**Federal Highway  
Administration**

September 2, 1999

Refer to: HMHS-B55A

My May 18 letter to you accepted the Alaska Multi-State Bridge Rail as a National Cooperative Highway Research Program (NCHRP) Report 350 test level 4 (TL-4) design. On August 6, you requested that a transition design for this bridge railing also be accepted by the Federal Highway Administration at TL-4. To support your request, you also sent copies of two July 1999 reports prepared by the Texas Transportation Institute, "NCHRP Report 350 Test 4-21 of the Alaska Multi-State Bridge Rail Thrie-Beam Transition" and "NCHRP Report 350 Test 4-22 of the Alaska Multi-State Bridge Rail Thrie-Beam Transition" and videotapes showing the two tests that were conducted.

Figure 1. Details of the Alaska Multi-State Bridge Rail Thrie-Beam Transition

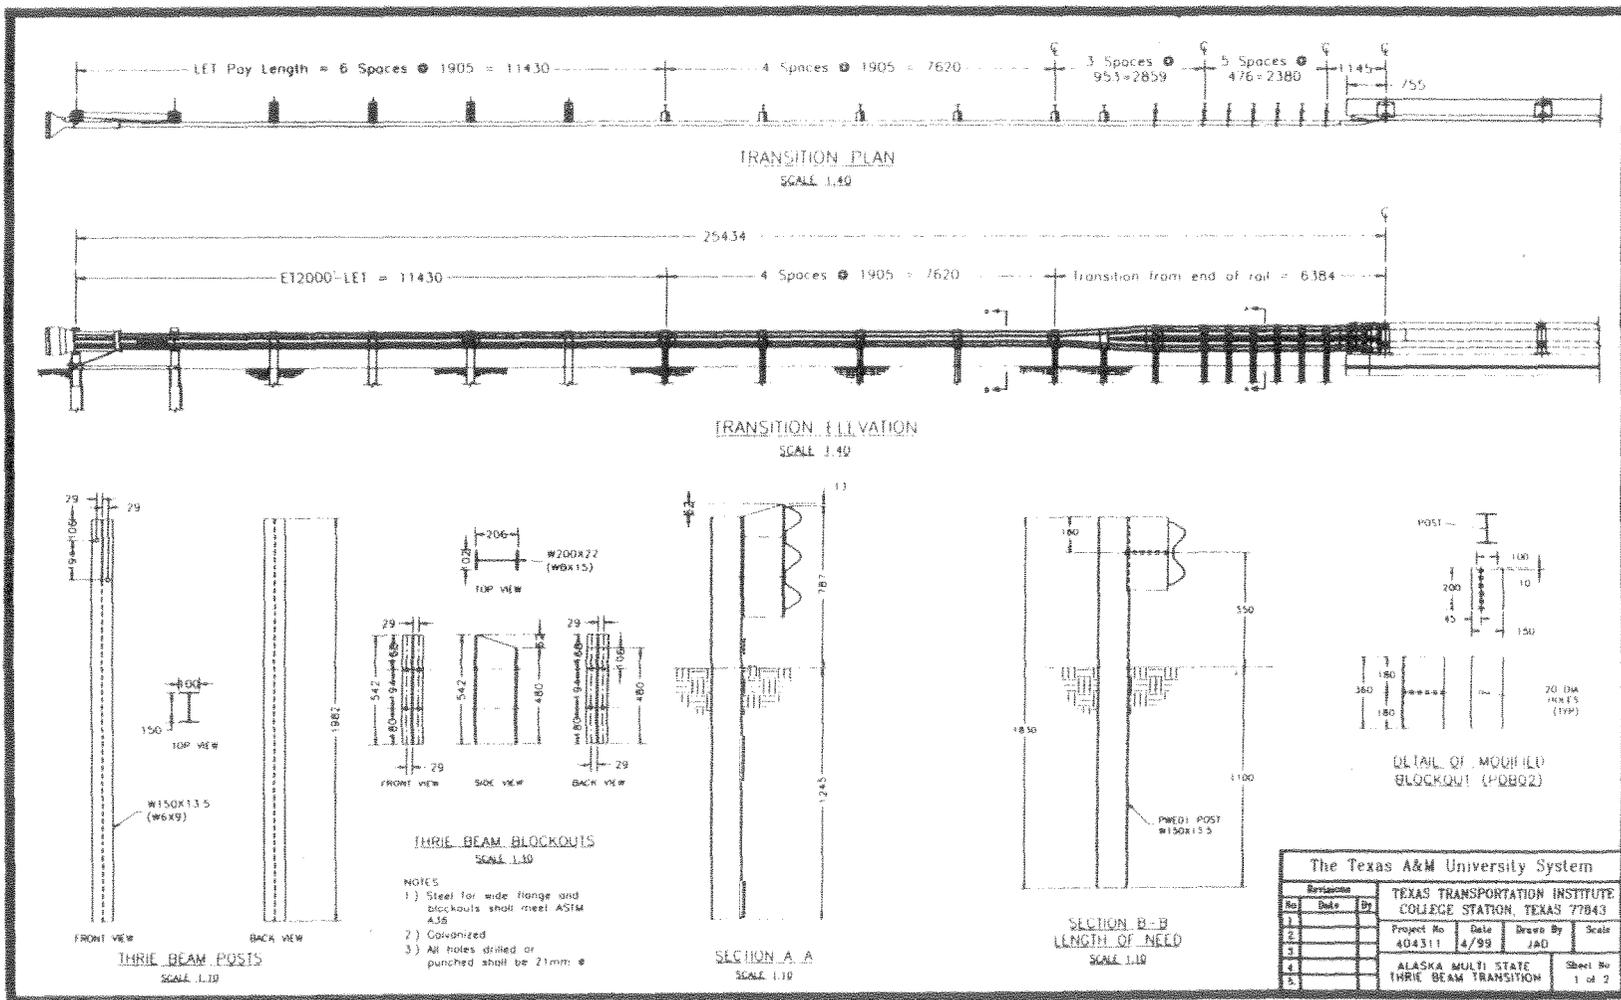
As shown in detail in Enclosure 1, the transition consists of nested 12-gage Thrie-beam panels supported by three 1982-mm long W150x13.5 steel posts on 953 mm centers followed by six 1982-mm long W150x13.5 steel posts spaced on 476 mm centers. All posts are set 1245 mm into the soil. The post immediately adjacent to the first bridge rail post is offset 1145 mm from the first bridge rail post. The Thrie-beam is connected to the bridge rail using a standard Thrie-beam Terminal Connector bolted to a special connection plate made from 10-mm and 13-mm thick steel plate and 10-mm and 6.35-mm thick steel angles. The concrete curb was flared back 114 mm over its last 457 mm to minimize wheel snagging at that point.

Based on staff review of the test reports and the videotapes, I concur that the transition design meets all appropriate evaluation criteria for a TL-4 design and it may be used in conjunction with your Multi-State Bridge Rail on the National Highway System when such use is requested by a transportation agency. I understand that the design, like the bridge rail, is nonproprietary and that copies of detailed plans and specifications can be obtained directly from you upon request.
